**Western Star
Service Bulletin**

Description of Revisions: *This bulletin replaces the version dated October 1992. Information is added about the turn signal switch for 4700 vehicles.*

Turn Signal and Brake Override Circuit

Fig. 1, Turn Signal Switch

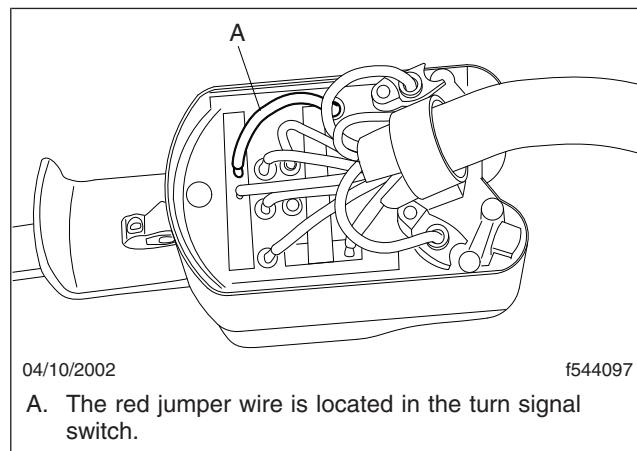
To enable 4-way override on all Western Star vehicles equipped without self-cancelling turn signal switches, remove the jumper wire located in the turn signal switch and tape it back. See **Fig. 1**.

Fig. 3, Wire 36A Modification

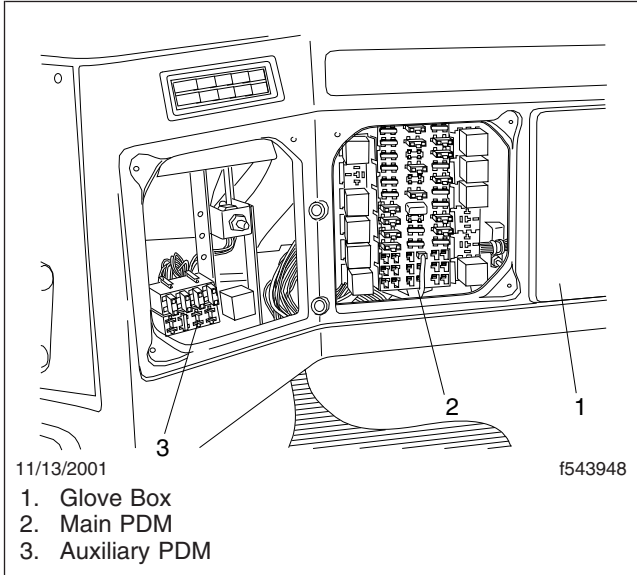
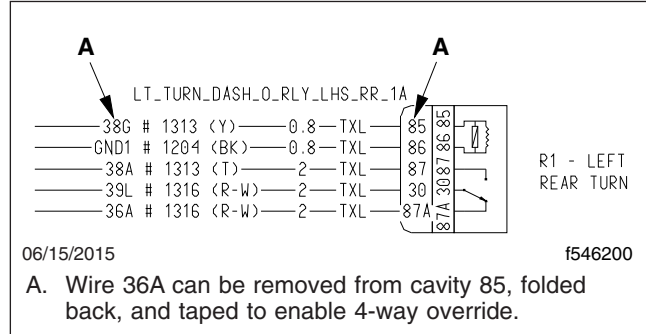
On 4700 models with self-cancelling turn signals, remove wire 36A (red with a white stripe) from cavity 85 on the auxiliary PDM, and tape it back. See **Fig. 2** and **Fig. 3**.
